Cable Assembly TP1-TP4 Insertion Loss (Comment #358)

Week of Sept 15, 2025

Comment #358

Current TP0d-TP5d Loss Budgets

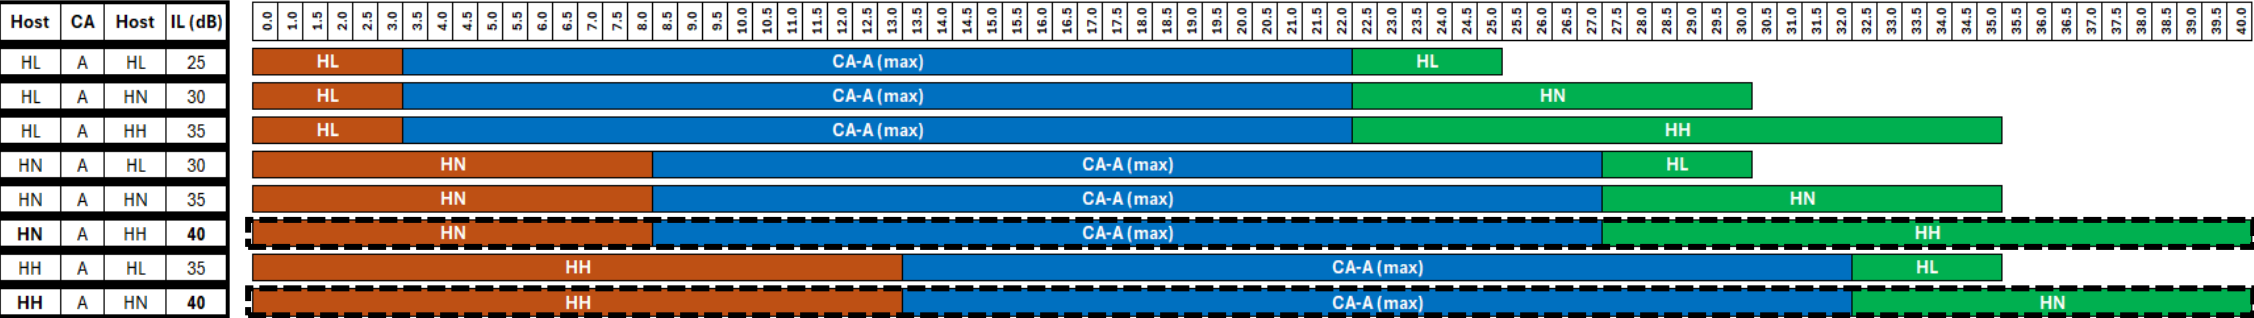
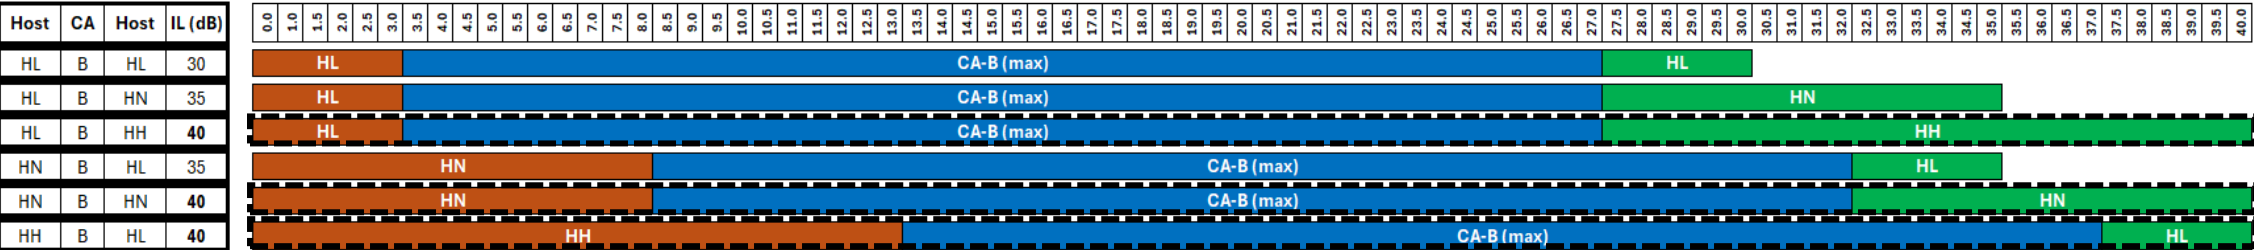
- 3 host classes. HL = 3 dB, HN = 8 dB, HH = 13 dB (maximum)
 - These are partial host losses. The full host loss includes an additional 5.95 dB that includes the reference packages and additional host PCB trace.
 - Full host loss: HL/HN/HH = 8.95/13.95/18.95 dB (maximum)
- 4 Cable Assy classes: CA-A = 19 dB, CA-B = 24 dB, CA-C = 29 dB, CA-D = 34 dB (maximum)
- The 40 dB total budget (die to die) constrains the allowed combinations of hosts and cable assemblies.

1.0m 26AWG & 1.0m 25AWG DAC, S_{DD21} @ 53.12GHz

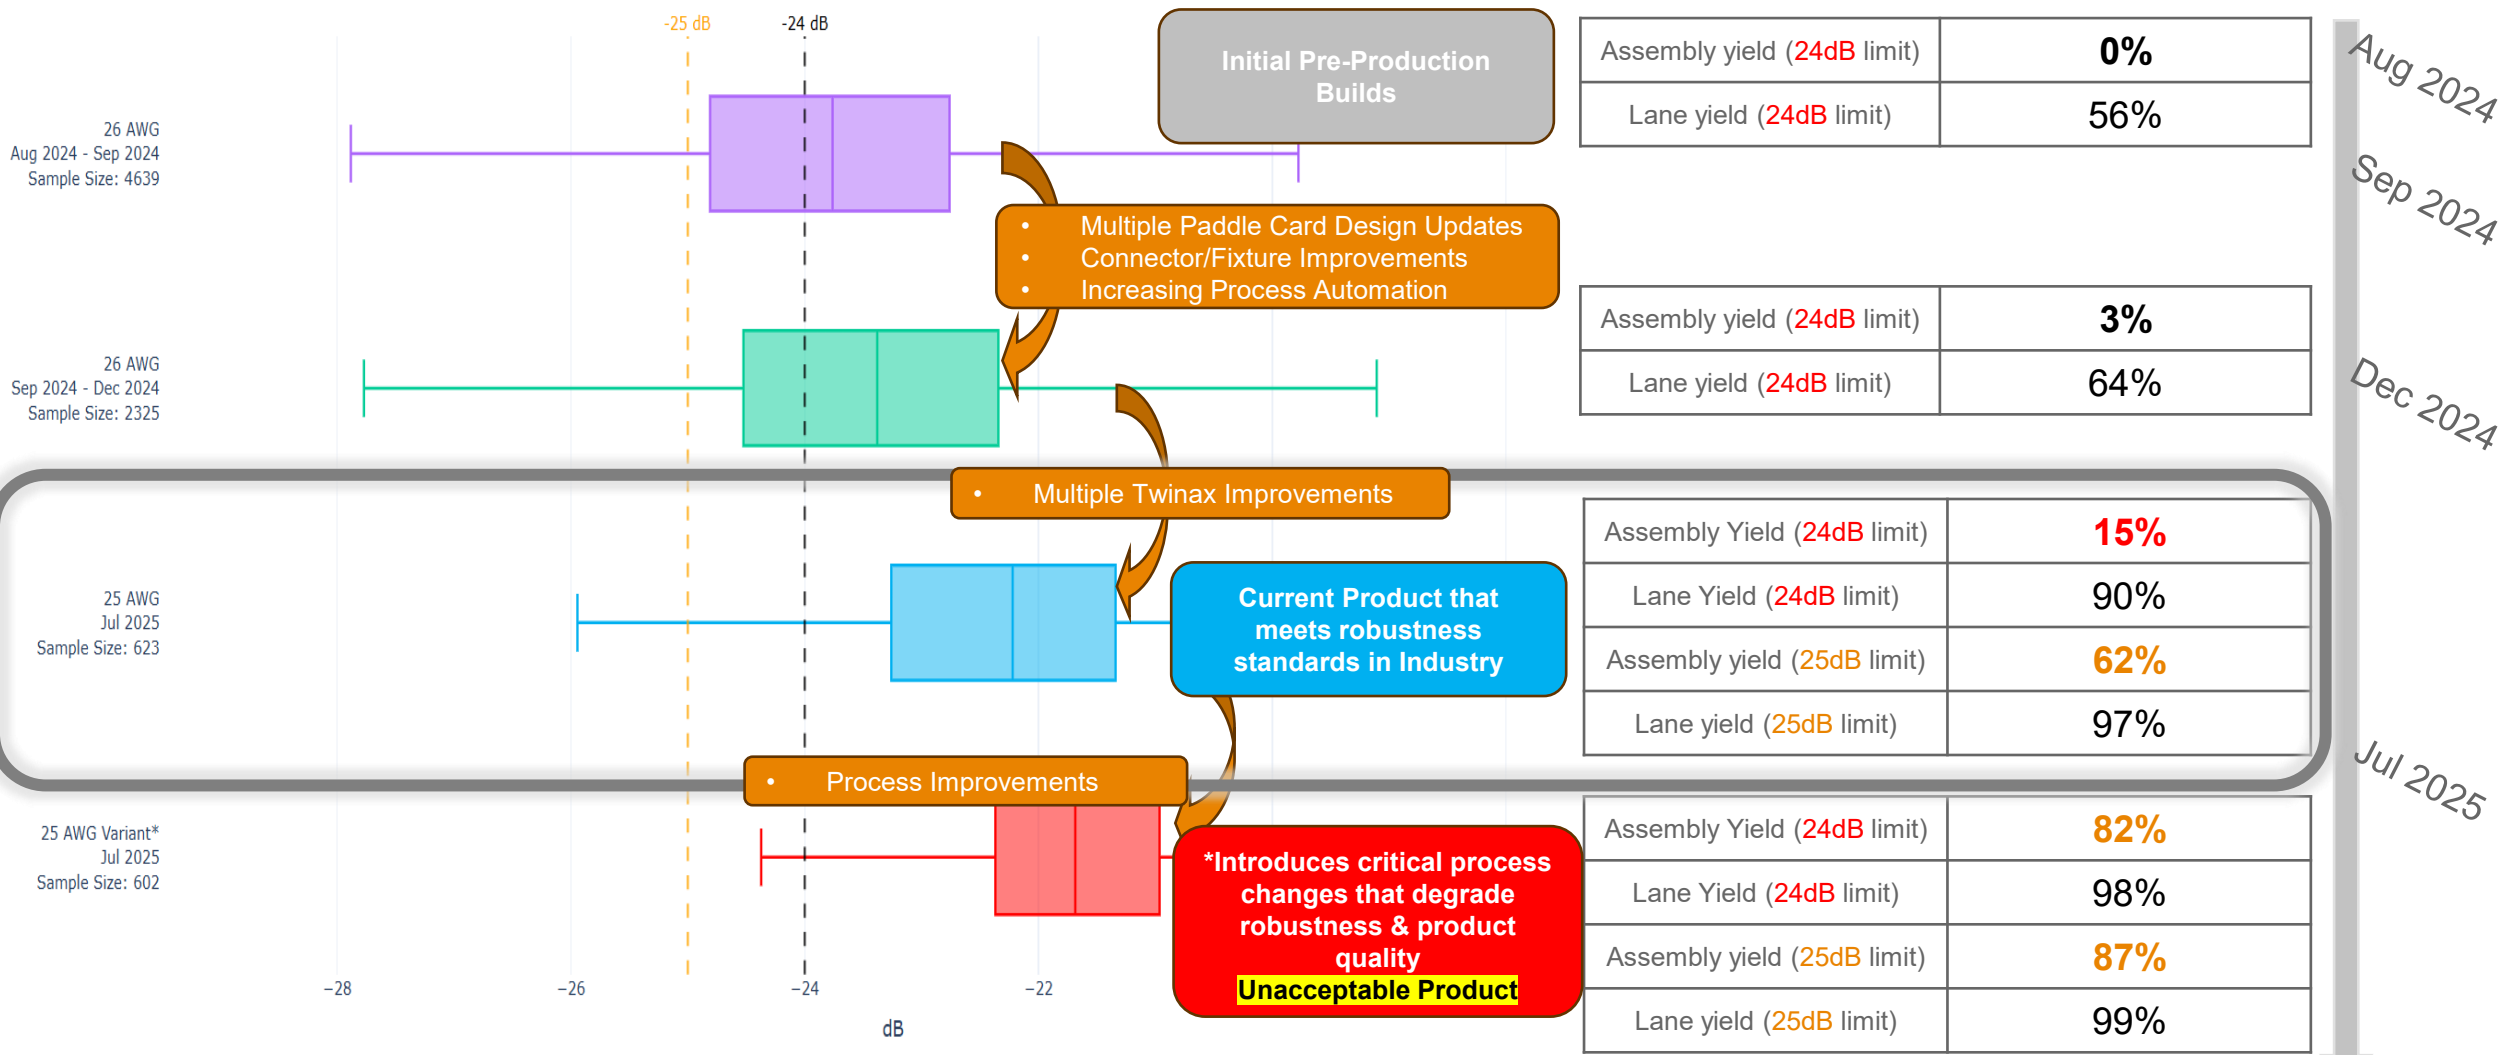
At the time CA-x budgets were set, there was insufficient cable assembly build experience

TP0d-TP5d Loss Budgets with Proposed Changes

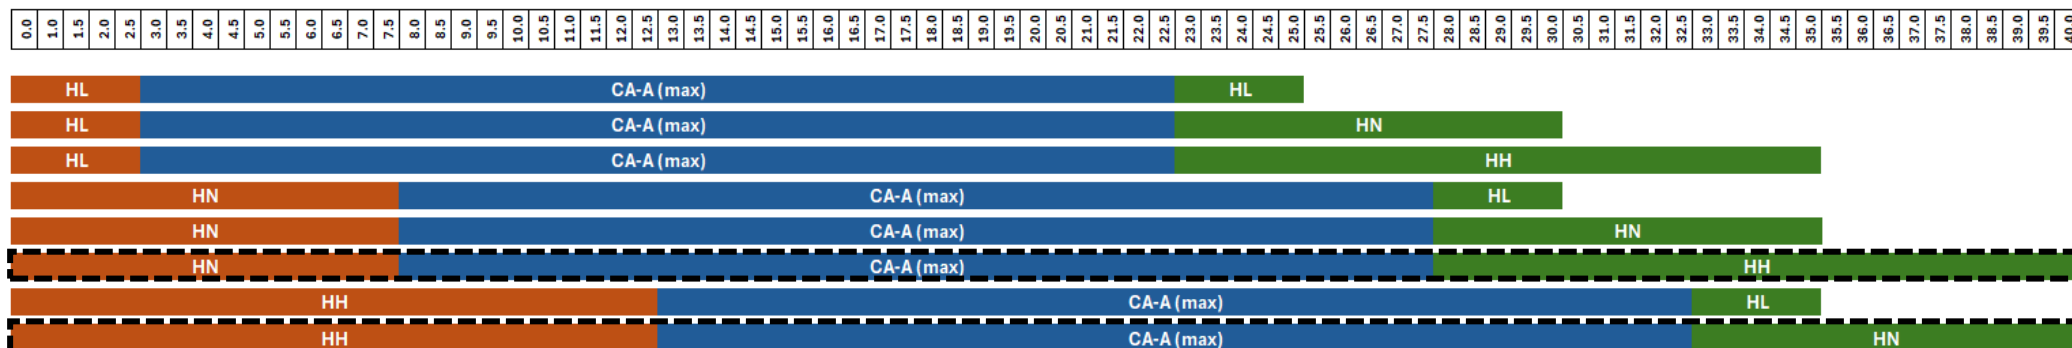
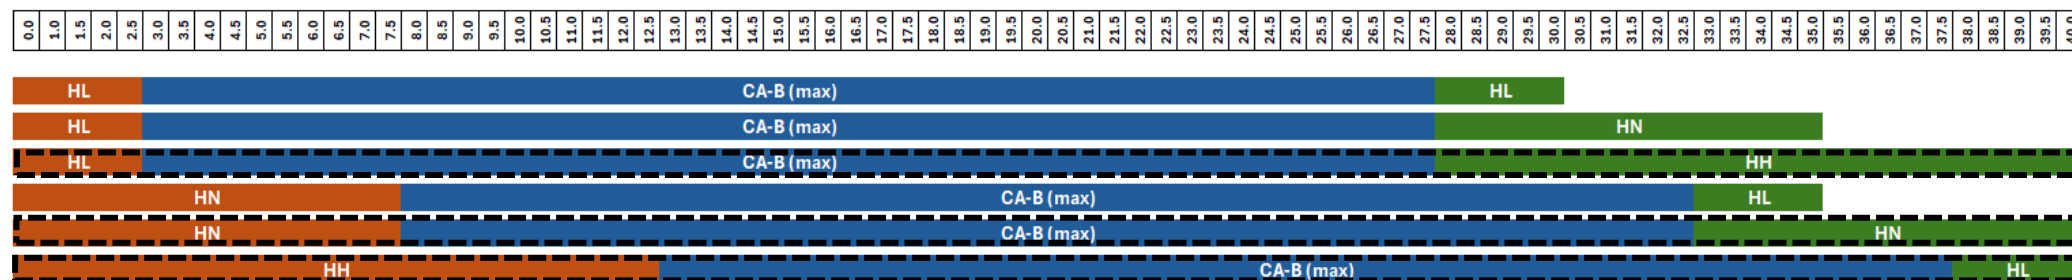
- Proposed partial host & CA insertion loss:
 - HL = 2.5 dB, HN = 7.5 dB, HH = 12.5 dB
 - CA-A = 20 dB, CA-B = 25 dB, CA-C = 29 dB, CA-D = 34 dB
- Host physical design impact: Assume all reduction from host PCB (no change to pkg).
 - 0.5 dB IL reduction ~10 mm trace length reduction on each host
 - Depends on dielectric material, surface roughness and stackup/trace geometry

Figure 179A-1—Host-Nominal to Host-Nominal, Cable assembly, and test fixture insertion loss at 53.125 GHz

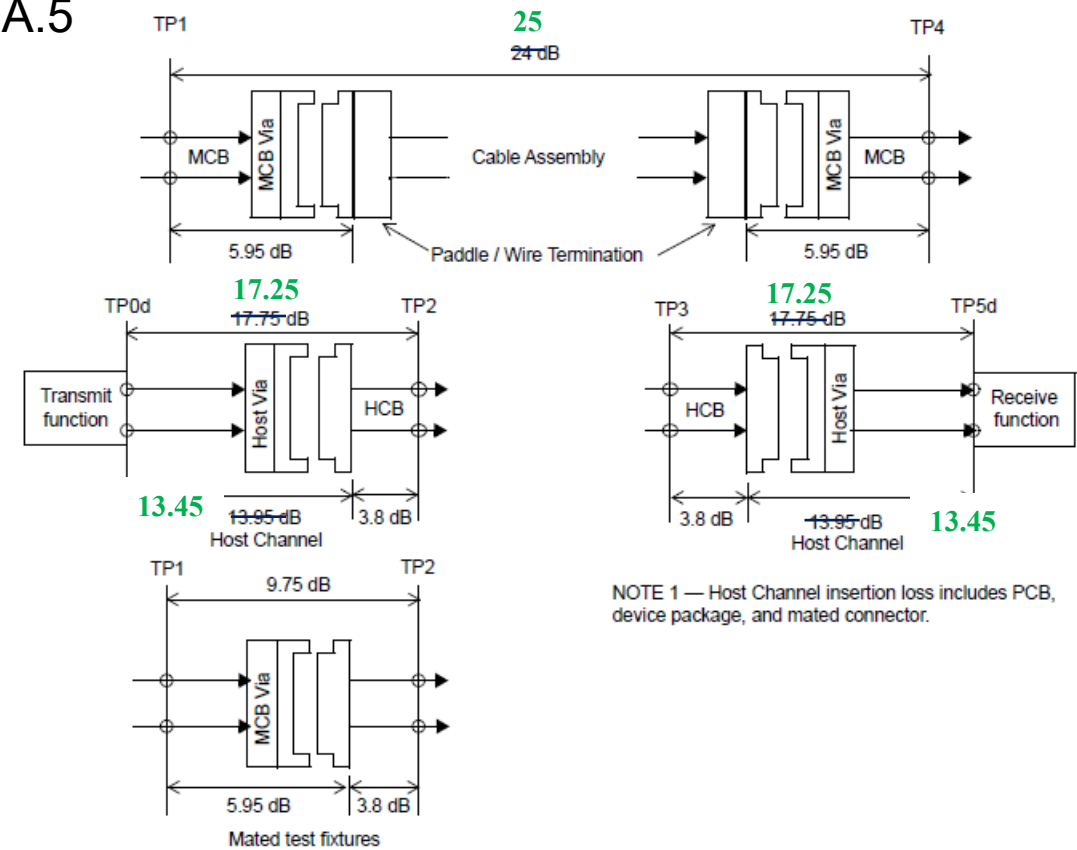
Proposed Changes

Channel Max (TP0d-TP5d) ILdd = 40 dB @ 53.125 GHz = (25+17.25+17.25)-(2*9.75)

Figure 179A-2—HN-to-HN Channel Max (TP0d-TP5d) at 53.125 GHz

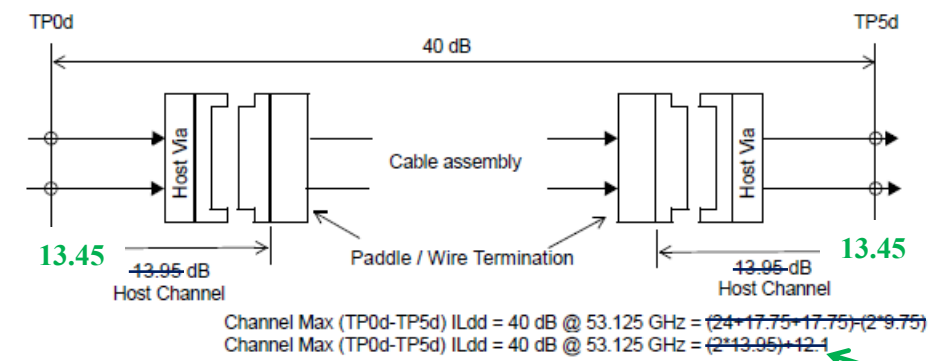
Channel Max (TP0d-TP5d) ILdd = 40 dB @ 53.125 GHz = (2*13.45)+13.1
